Airstream Service Bulletin

Bulletin Number: 173

Product Line: 2018 30' & 33' Airstream Classic Travel Trailers

Subject: Alde Connector

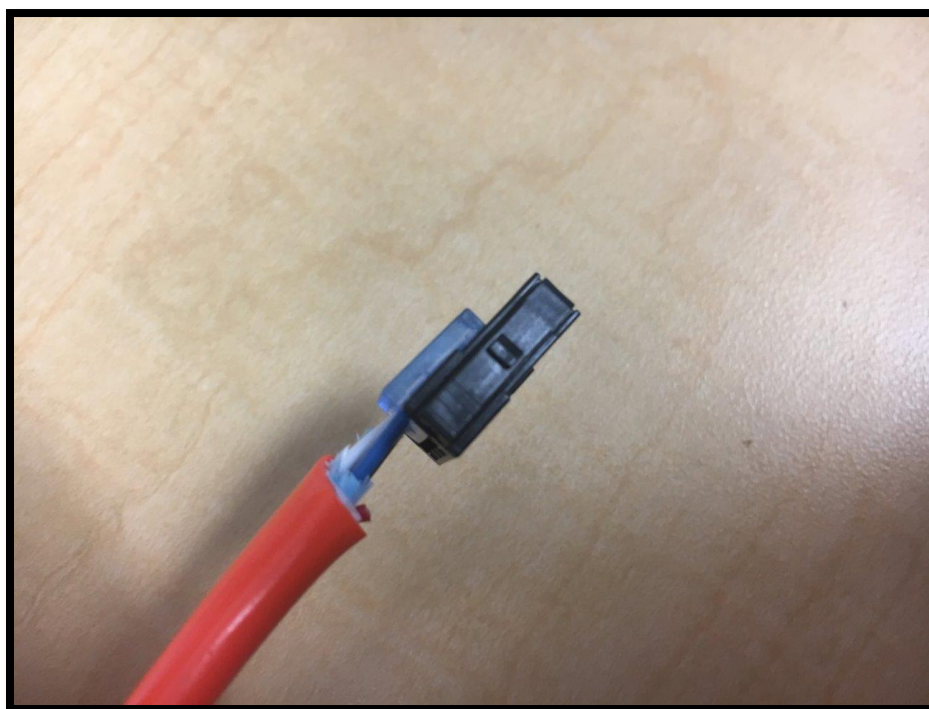
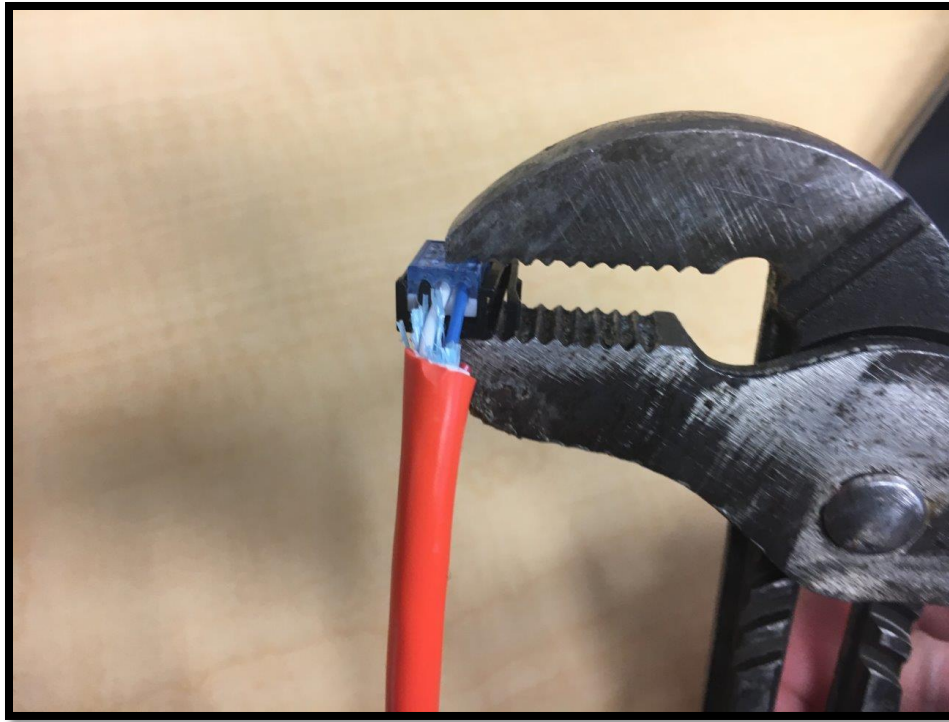
It has come to our attention that there may be an opportunity for a 3 pin connector to be wired incorrectly on the G6 panel in certain 2018 Classic travel trailers. This may cause the Alde heating system to cycle incorrectly.

Step 3: Verify the wiring sequence on port 3 of the G6 panel. It should be wired as pictured below, with the blue wire closest to the clip, white in the middle and black furthest away from the clip:

Step 4: If the connector is not in the correct order pictured above, a new one will need to be installed. Be sure to cut the wires one at a time. Insert into the new connector in the correct order. There is no need to strip the protective coating from the individual wires. Then, using a pair of channel locks (you do not need a special tool to crimp this connector), compress the blue part of the clip down to secure the connections and reinsert back into the G6 panel. Cycle the 12V system off and back on to reset the system.
